SRS test diagram
draft figure for MMF ad hoc,
post review

27 March 2014

Clause 95

Figure 95-3—Stressed receiver conformance test block diagram

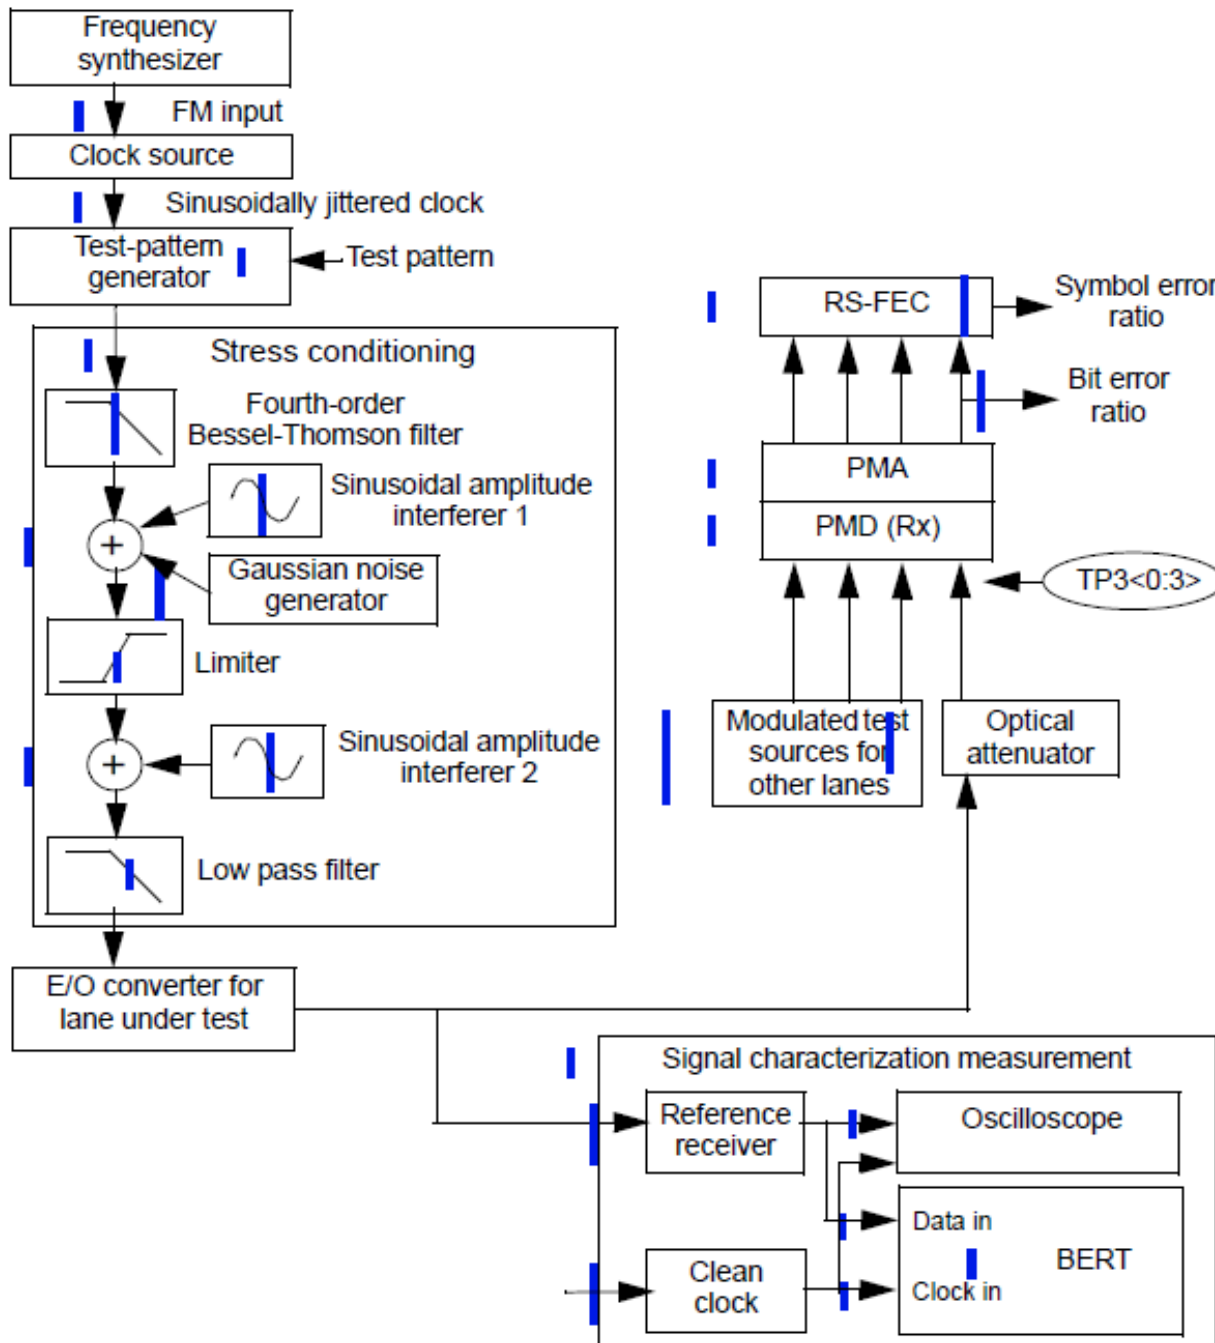
95.8.8 text should say

- Can either measure error ratio at the PMD/PMA interface
- Or measure errored symbols at the input to the RS-FEC
